LONG-TERM ONTROL PLAN '98

Mr. Paul Novak, P.E.
Manager Permits & Compliance Section
Division of Surface Water, Ohio EPA
Lazarus Government Center
122 S. Front Street
Columbus, Ohio 43215-1099

Re: City of Akron

CSO Long Term Control Plan (LTCP)

Figure 1. Calculation of Treated Volume When Inflow to WPCS Above Annual Average

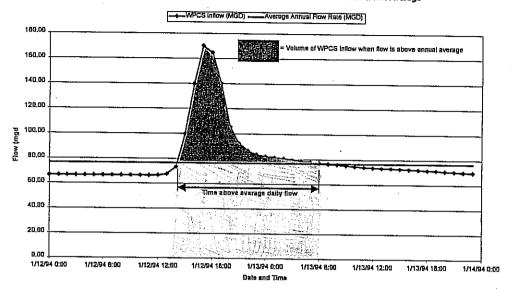
The purpose of this letter is to provide Ohio EPA with the information that was requested in your letter of May 25, 2000 concerning Akron's Long Term Control Plan ("LTCP"). For the sake of convenience, the information set forth below is provided in the same order as requested in your letter; i.e., a summary of the data justifying the calculated 94% flow capture, additional information supporting the prioritization of the projects set forth within the LTCP, and confirmation of Akron's financial commitment for the implementation of the LTCP. In the event that Ohio EPA has any additional questions with regards to the LTCP, we would be more than willing to meet with you and other representatives of the Ohio EPA to address the same.

Figure 1 shows a model generated inflow hydrograph at the WPCS. The flow data is given in hourly time steps ($\Delta t = 1$ hour). At each time step, the WPCS inflow rate, Q_i , was checked against the daily average flow rate of 76.5 MGD¹ (118.4 cfs). This daily average flow rate was taken from the 1998 Akron Facilities Plan. If the WPCS inflow was higher than the average daily flow rate, a precipitation event is said to be occurring and an incremental volume was calculated:
